RE: TDN #89-02-116-002, Blazon Mine No. 1, North American Equities,
ACT/007/021, Carbon County, Utah

Re: TDN #89-02-116-002, Blazon Mine No. 1, North American Equities, ACT/007/021, Carbon County, Utah

TYPICAL SECTION RECLAIMED MINE BENCH

FIGURE 7

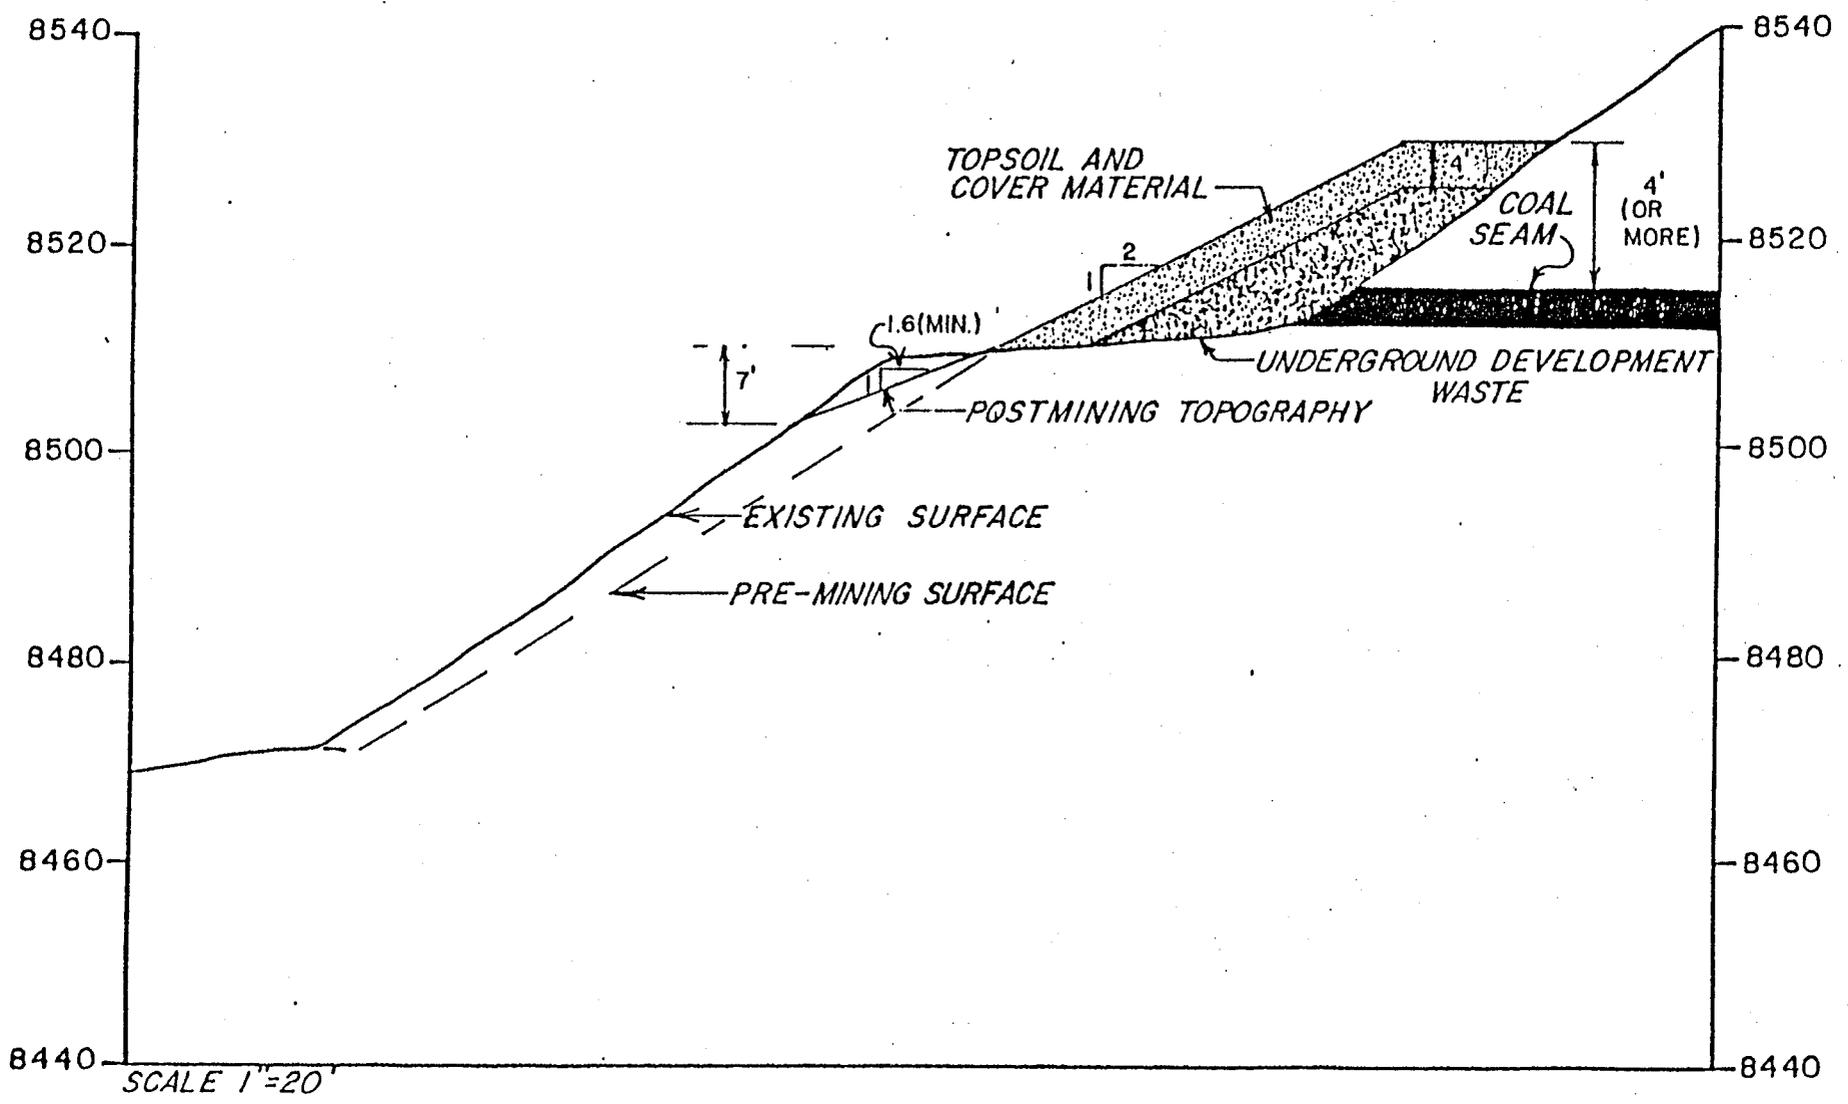
I have also attached a copy of Figure 7, from the approved mining and reclamation plan Typical Section of Reclaimed Mine Bench, which supports the final configuration of a cut and fill terrace on the portal bench.

The as-built configuration of the reclaimed portal bench is generally that depicted in the above-referenced Figure 7. In the approximate center of the reclaimed portal bench, the present configuration of fill placement blends into the undisturbed slope with the elimination of the cut and fill terrace for roughly 40 feet. Examination of photographs taken during the past two field seasons (including those sent you earlier this year) suggests that where the cut and fill terrace was not implemented, runoff has been concentrated across the fill, with the resultant need to place the log erosion control devices shown in the photographs.

Clearly, the cut and fill terrace is functioning as contemplated in the regulations with the minor exception noted above. The placement of the log erosion control devices has, as noted, allowed the reclaimed configuration to meet performance standards.
